New Model Introduction

New Model GR-4100 is offered as a direct replacement for model GR-6030V. Models have common mounting and tooling and are dimensionally the same except as shown.

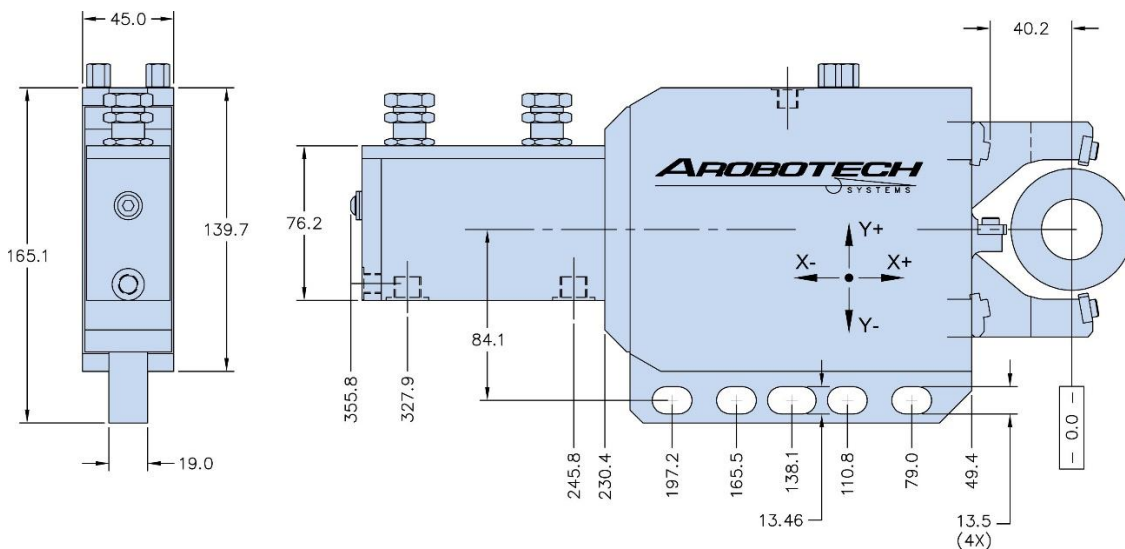
- * 30 to 60mm Diameter
- * 10.3° Turn = 0.001mm Adjustment
- * +/- 0.068mm Total Adjustment

- * 20 to 60mm Diameter
- * 90° Turn = 0.001mm Adjustment
- * +/- 0.200mm Total Adjustment
